# HISTORIC PRESERVATION ADVISORY COMMITTEE

## REPORT TO THE CITY OF VISALIA HISTORIC PRESERVATION ADVISORY COMMITTEE

**SUBJECT:** Historic Preservation Advisory Committee Item No. 2025-13: A request by Michael Murphy to conduct a reroof, add and replace fascia boards, restore or replace soffit boards, and replace wood rain gutters with metal rain gutters, on a single family residence within the D-MU (Downtown Mixed Use) Zone. The project site is located at 539 North Locust Street (APN: 094-354-005).

**A1**  
DEMO & NEW

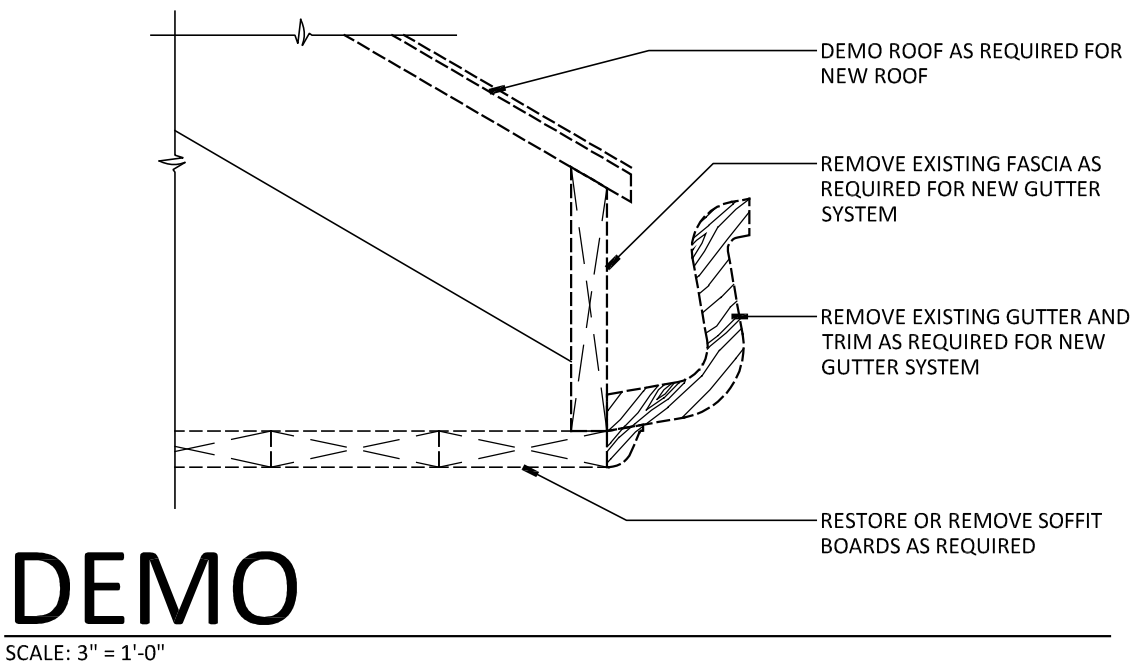
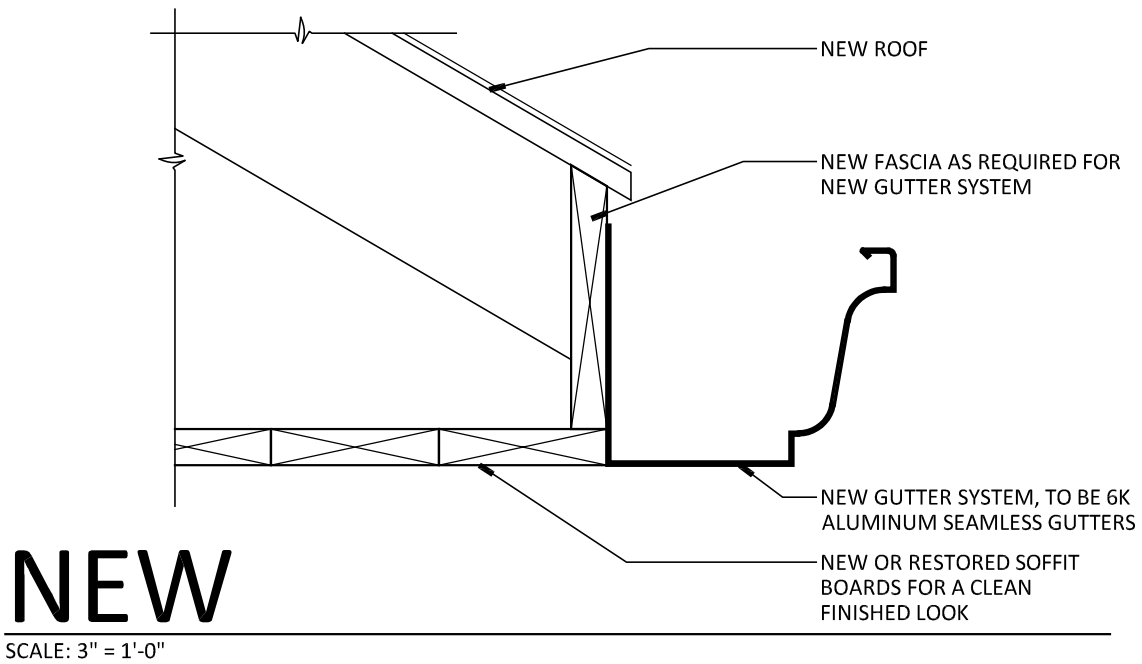
We will be adding fascia to the eaves of the second story, fascia size to match existing.

Remove these existing gutters and replace with new 5k style wrap around gutters

Evidence of wood rot in the original wooden gutter system, which has carried into fascia area

Rafter tails exposed, in decent condition, we would like to install fascia on all exposed rafter tails
